ABBOTT ADD	<h1>TECHNICAL SERVICE BULLETIN</h1>
--	-------------------------------------

SUBJECT: **TDx® Analyzer Revision 16.0 Software Upgrade**

TSB#: **09-040**

SUBJECT:
TDx® GROUNDING

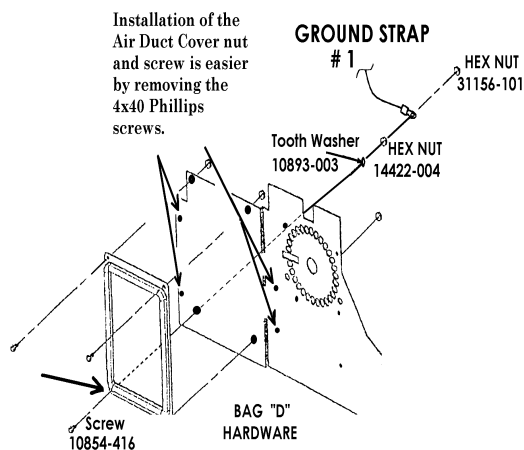
With the Air Duct Cover still installed in the instrument, remove the left front screw and nut that holds the Waste Receptacle to the Air Duct Cover. Install the screw from BAG D through the Air Duct Cover and attach the washer and the 14422-004 standard nut from BAG D on the underside of the Air Duct Cover. Tighten the nut so the washer "cuts" into the Air Duct Cover.

Attach the ground strap to the Air Duct Cover, as illustrated below, using the 31156-101 KEP Hex Nut from BAG D.

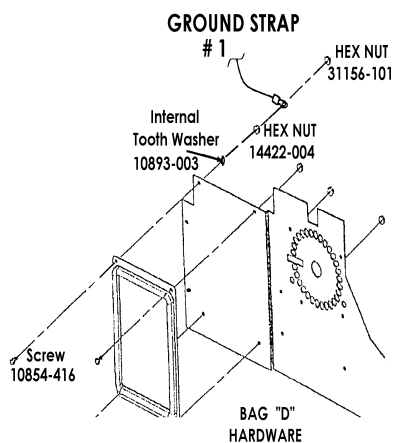
STEP 10 On the Air Duct Cover, remove the screw and nut located at the top left corner. This screw and nut are one of four that hold the Waste Tray Receptacle onto the Air Duct Cover. Install the screw from BAG D through the Air Duct Cover and attach the washer and the 14422-004 standard nut from BAG D on the underside of the Air Duct Cover. Tighten the nut so the washer "cuts" into the Air Duct Cover.

Attach the ground strap to the Air Duct Cover, as illustrated below, using the 31156-101 KEP Hex Nut from BAG D. Install the Air Duct Cover into the instrument.

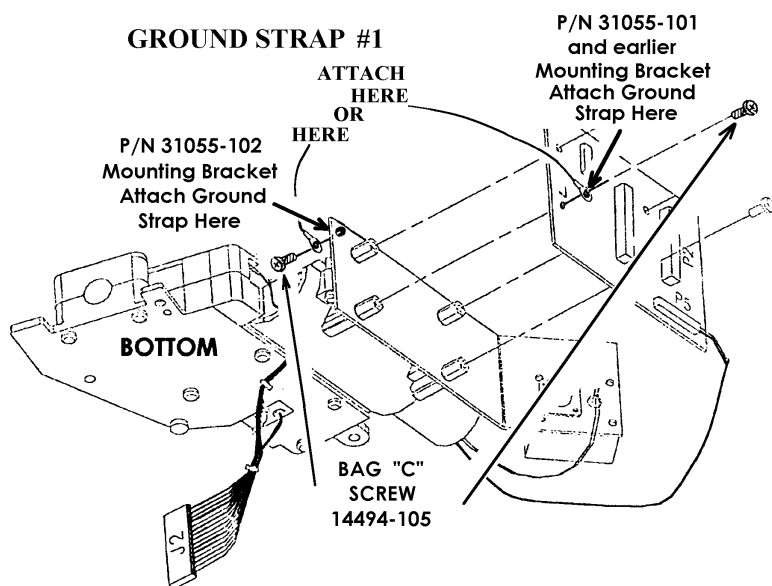
STEP 11 Referring to the illustration below, attach the ground strap, to the one (1) appropriate location on the Optics Assembly.

STEP 11 Referring to the illustration below, attach the ground strap, to the one (1) appropriate location on the Optics Assembly. Install the Optics Assembly and the Boom Assembly into the instrument.

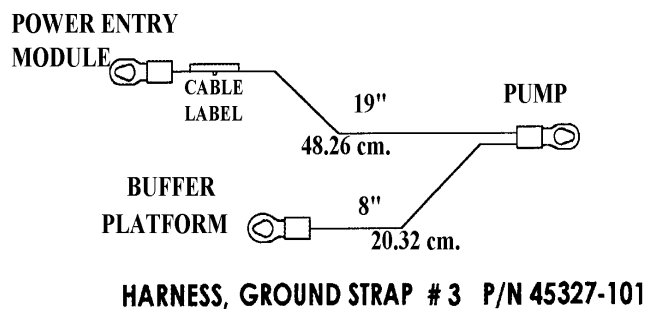
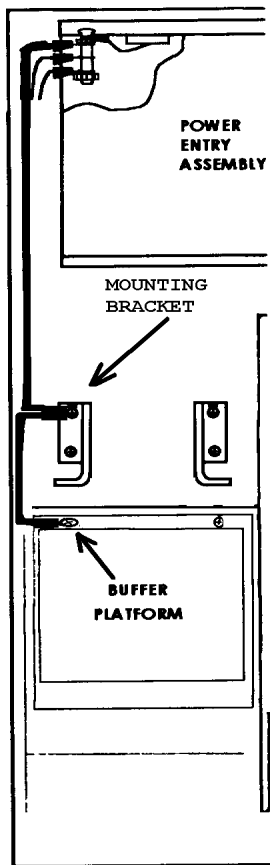
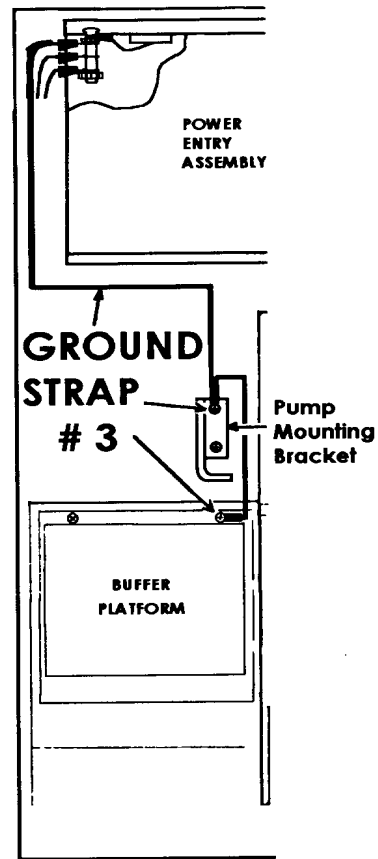
STEP 12 HARNESS GROUND STRAP #3. Attach ground strap #3 to the back screw that secures the pump mounting bracket to the instrument base. Then route the ground strap under the Pump Assembly front cover and attach to the Buffer Platform.

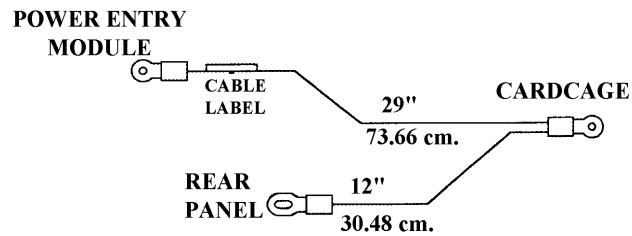
STEP 13 HARNESS GROUND STRAP #2. Remove the self-tapping screw from the top of the cardcage. Attach the ground strap #2 to the top of the cardcage using the self-tapping screw.

HARNESS, GROUND STRAP #2 P/N 45206-102

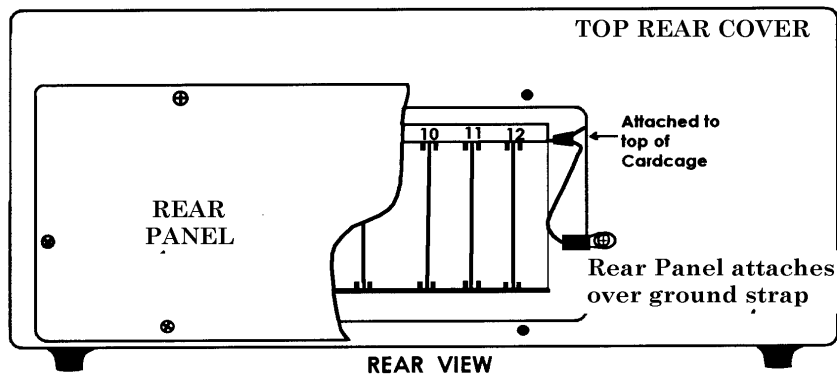
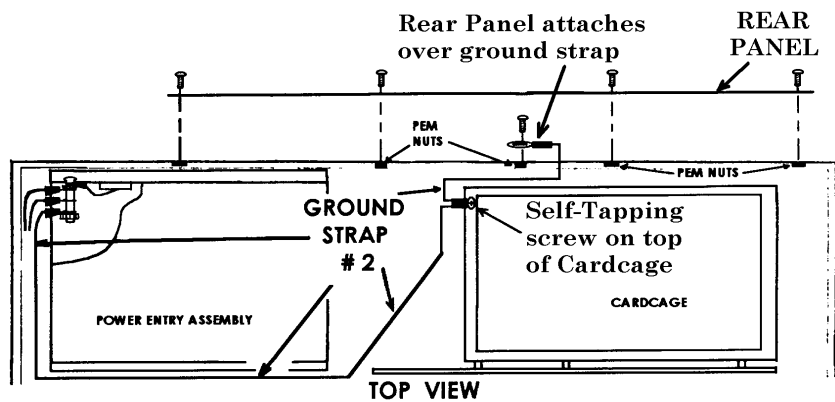
- STEP 14** Install the Left Side Panel and the Top Rear Cover. Plug P9 and P10 for the printer into their respective connectors on the Motherboard PCB.
Using the 14494-206 screw from BAG B attach Ground Strap #2 to the outside of the Top Rear Cover as shown.

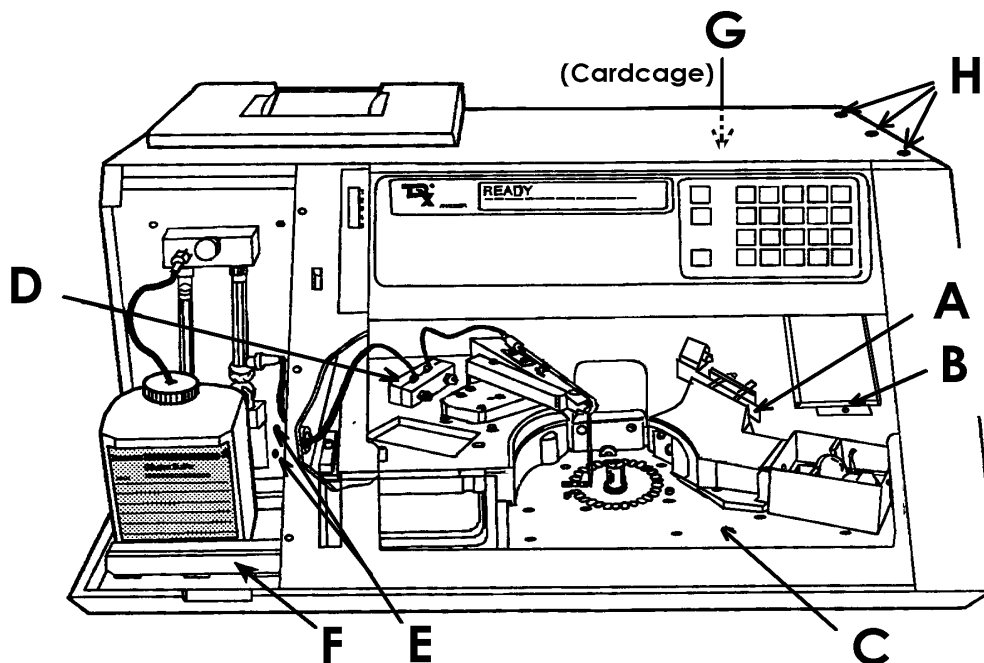
- STEP 2.** All resistance readings are to be referenced to the ground terminal of the Power Entry Assembly.

A resistance measurement greater than one (1) ohm requires the service representative to tighten the terminals on the ground strap and the Power Entry Assembly.

- STEP 3.** Measure the resistance between the ground terminal on the power receptacle and the following locations:
- A Optics PCB mounting bracket....
 - B PMT High Voltage Supply retaining screw
 - C Air Duct Cover (**NOTE:** The Air Duct Cover has an anodized coating. Scratch through this anodized layer to make the resistance measurement.)
 - D Liquid Heater
 - E Pump Assembly mounting screw
 - F Buffer Platform
 - G Cardcage
 - H Instrument covers

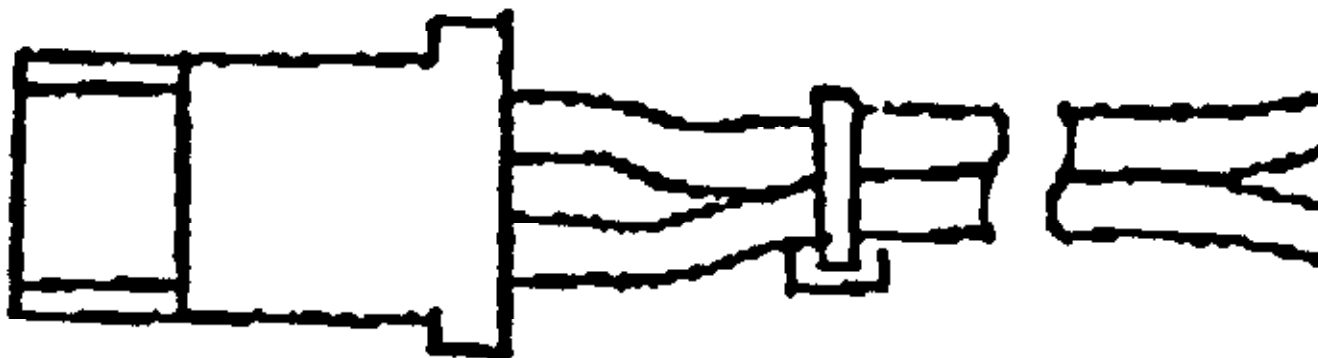
A wire retainer was added to the Lamp Socket to relieve stress on the wires during lamp replacement. This improvement is made to reduce LAMP OUT errors.
